PLANT NAME: THREE MILE ISLAND - UNIT 1

Three Mile Island Nuclear Station Unit 1 (TMI-1)
Operating License No. DPR-50
Docket No. 50-289
Cask Drop Analysis Additional Information

CASK DROP ANALYSIS

ADDITIONAL INFORMATION

PLAN-FUEL HANDLING BUILDING
ELEVS. 348'-0" AND 305'-0"
FIGURE 1

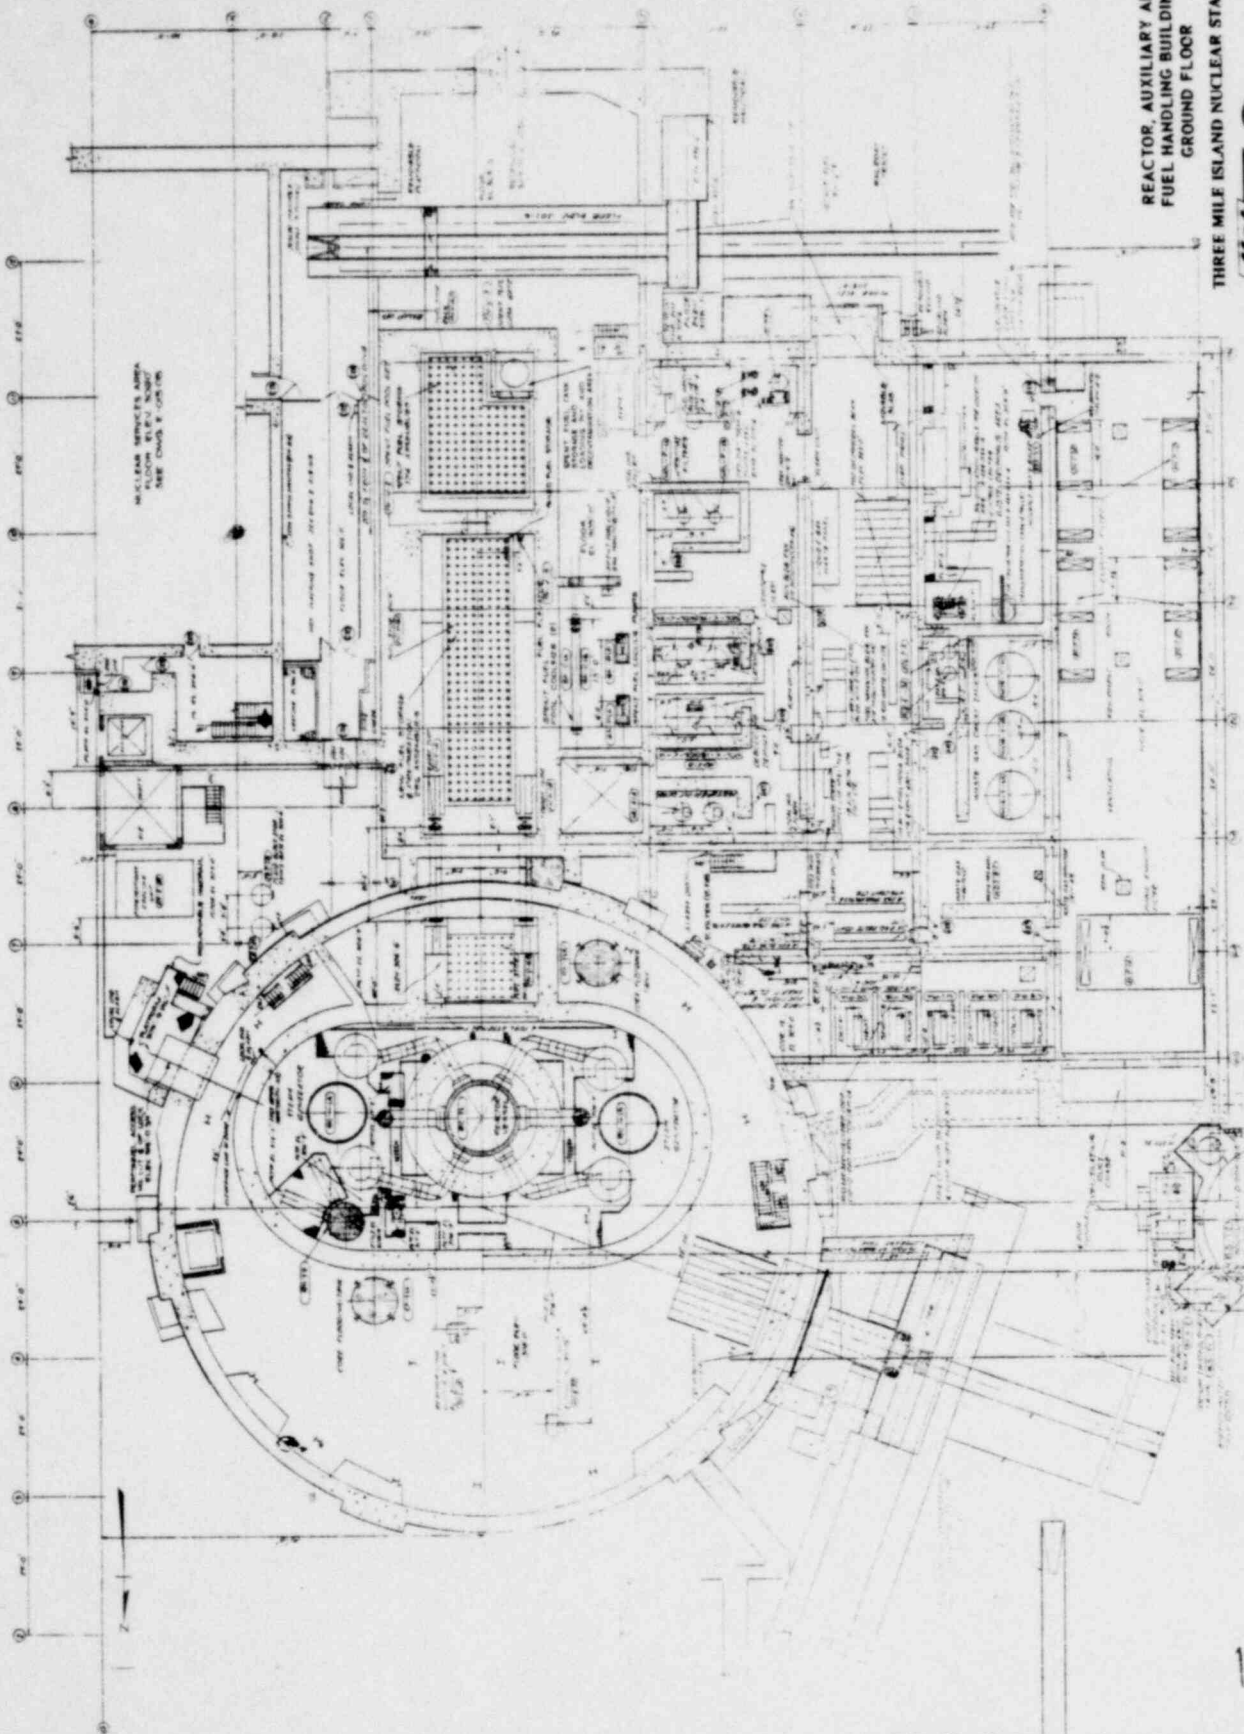
- 1.1 Provide one drawing showing the relative location of the following areas of Unit 1: (i) the new fuel storage areas; (ii) the spent fuel storage pool; (iii) the spent fuel cask storage and loading pit; and (iv) the specific location of the cask decontamination area.

1.2 To adequately evaluate the potential for unsafe conditions occurring in Unit 1 following a cask drop accident at any point along its revised path of travel between the transporter, the newly located decontamination area, and the spent fuel cask loading pit, superimpose the travel paths of the shipping cask for Unit 1 and 2 within the Unit 1 building on the drawing requested above.

1.3 Verify that the path of travel of the spent fuel cask from the transporter to the Unit 2 building has not changed due to these proposed changes or describe, discuss and demonstrate that no safety related consequences could result from these changes.

The requested information is shown on Figure 1.

The travel path of the shipping cask for Unit 1 and 2 within the Unit 1 building is shown on Figure 1.

The path of travel of the spent fuel cask from the transporter to the Unit 2 building remains as shown in the TMI-2 FSAR, Volume 8, Section 9.1.4.2.2. See Figure 1.

As shown on Figure 1, the area south of the railroad track is no longer designated as a temporary storage area for new fuel. New fuel will be receipt inspected in this area and then will be transferred to the new fuel storage racks shown in Figure 1 or to the spent fuel pools. No new fuel will be permitted in the receiving/shipping area during cask handling operations. Therefore the questioned impact of an accident on Unit 1 temporarily stored new fuel cannot occur.

FSAR Figure 9-18A will be revised showing the new key interlock limits of travel of the crane. This will be accomplished by substituting Figure 1 for 9-18A. Additional details are also shown in Figures IV-4 and IV-6 of the February 14, 1976, submittal.

FIGURE 1-3

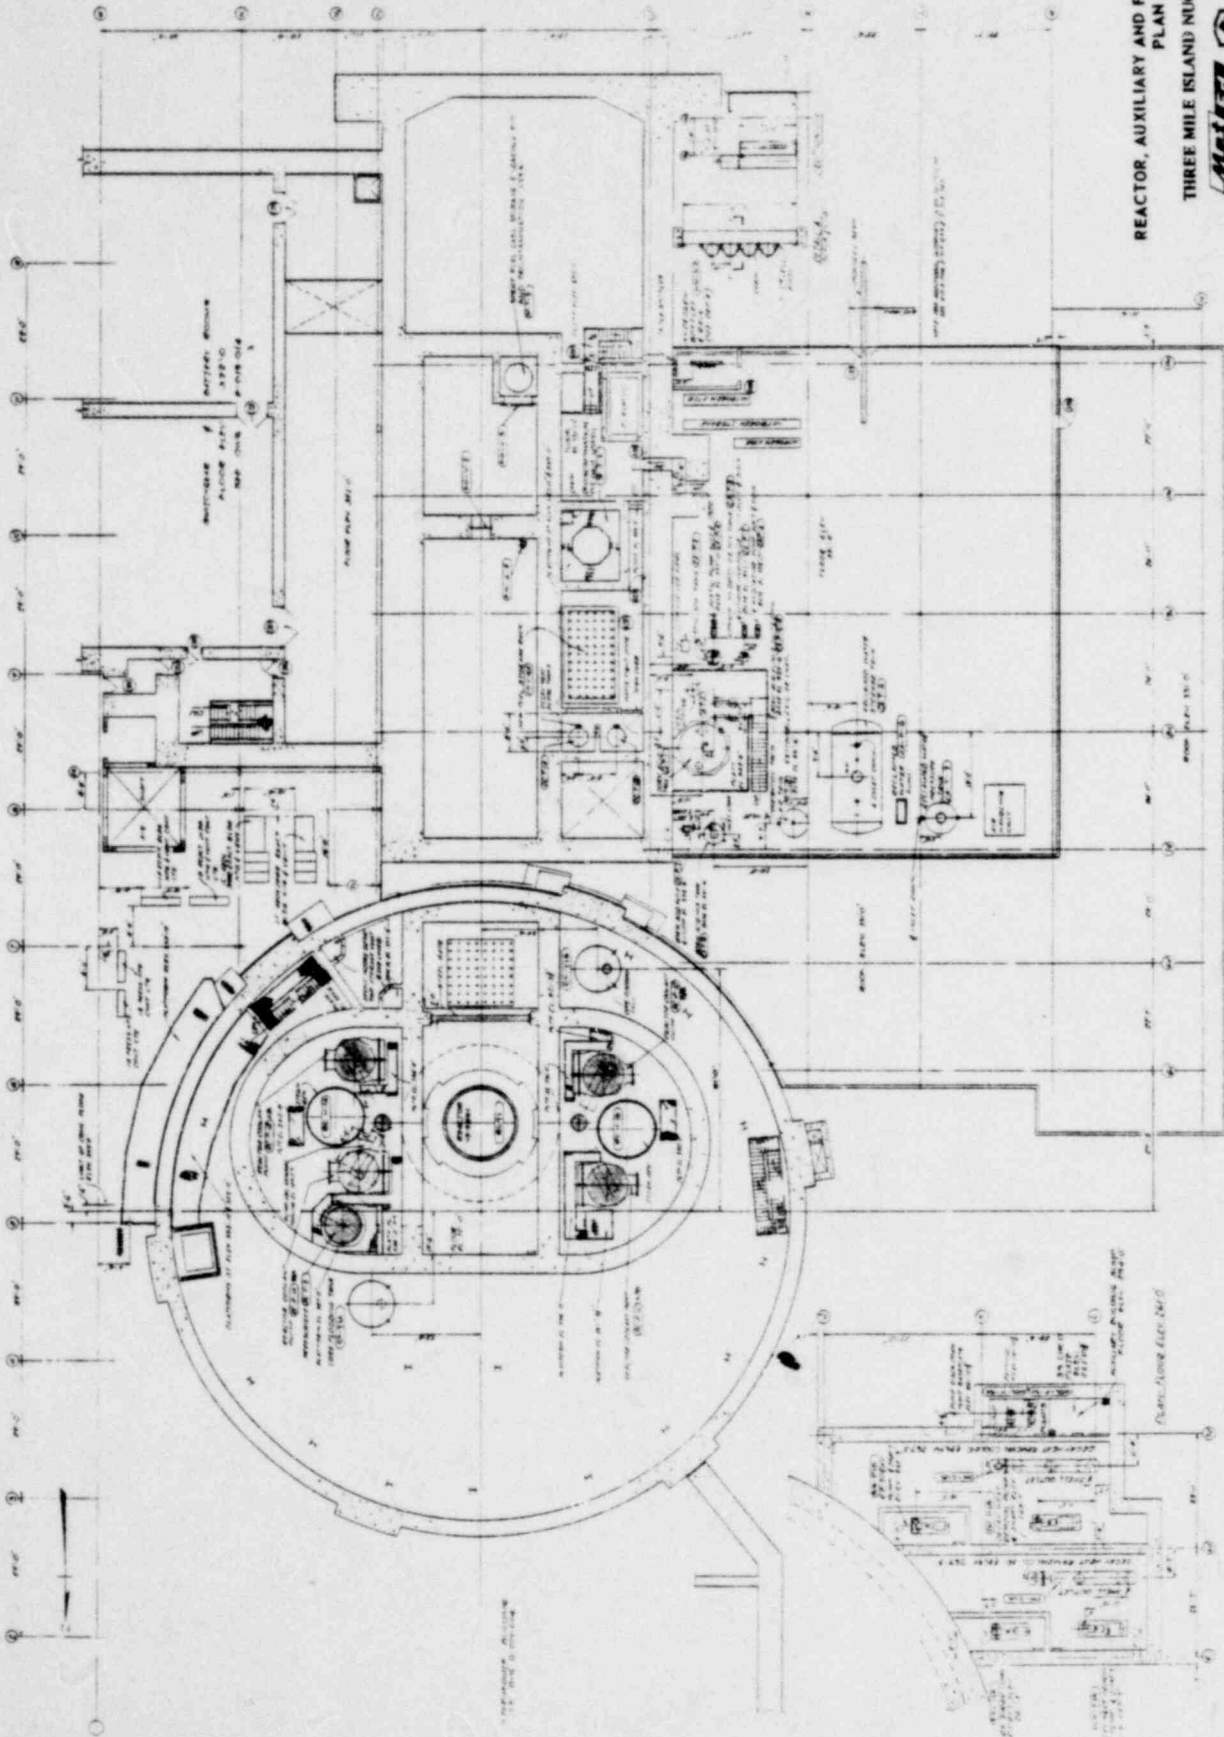
submittal. Further, FSAR Figure 1-3 shows that the Unit 1 temporary new fuel storage area is located parallel to the transporter railroad tracks and could be in the path of the spent fuel cask as it travels to and from the Unit 1 decontamination area as well as the corresponding work stations in Unit 2.

Figure 1-3 TMI-1 FSAR

- (1) "Temporary New Fuel Storage Rack" changed to "Receiving/Shipping Area."
- (2) "Spent Fuel Cask Storage Area" changed to "Spent Fuel Cask Storage & Loading Pit and Decontamination Area."

FIGURE 2-A

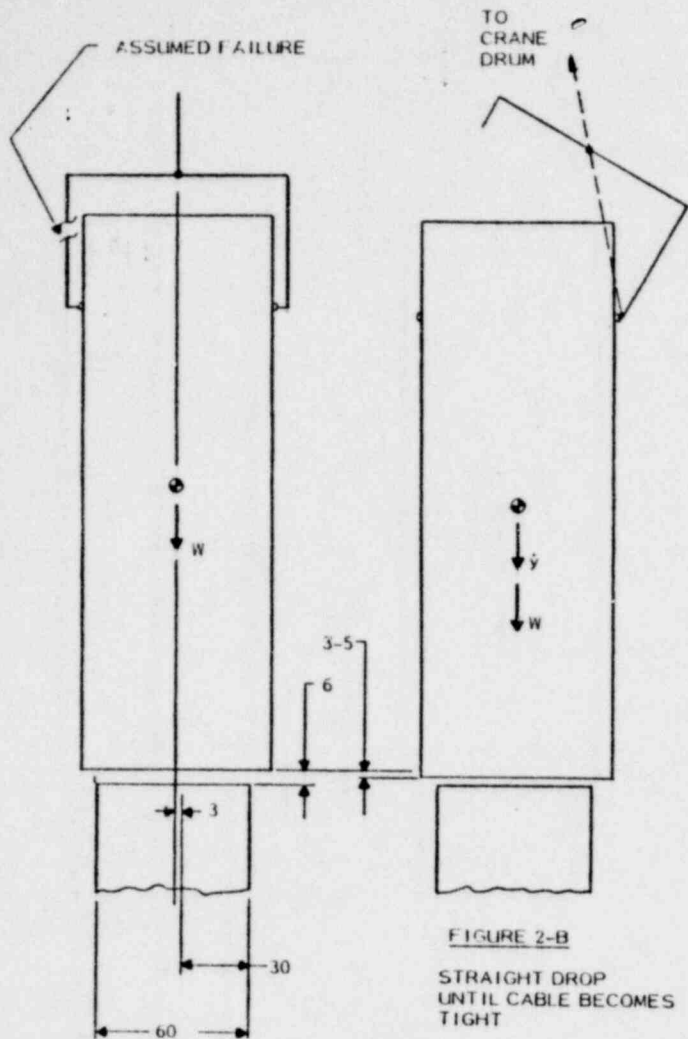
12.0 Provide a summary of the cask stability analysis when the cask is dropped on the south wall of the "B" spent fuel pool for both eccentric and straight drop conditions."

1. The cask bottom surface is assumed to be raised 6 inches above the top of the spent fuel pool wall and the cask center of gravity is assumed to be located 3 inches from the center of the 6-inch wide transfer path as shown in Figure 2a.
2. The lifting trunnion or lifting yoke arm on one side of the cask is assumed to fail. This lets the cask drop straight down 3 to 5 inches (depending on the cask involved) until the resulting slack in the system is removed, i.e.,
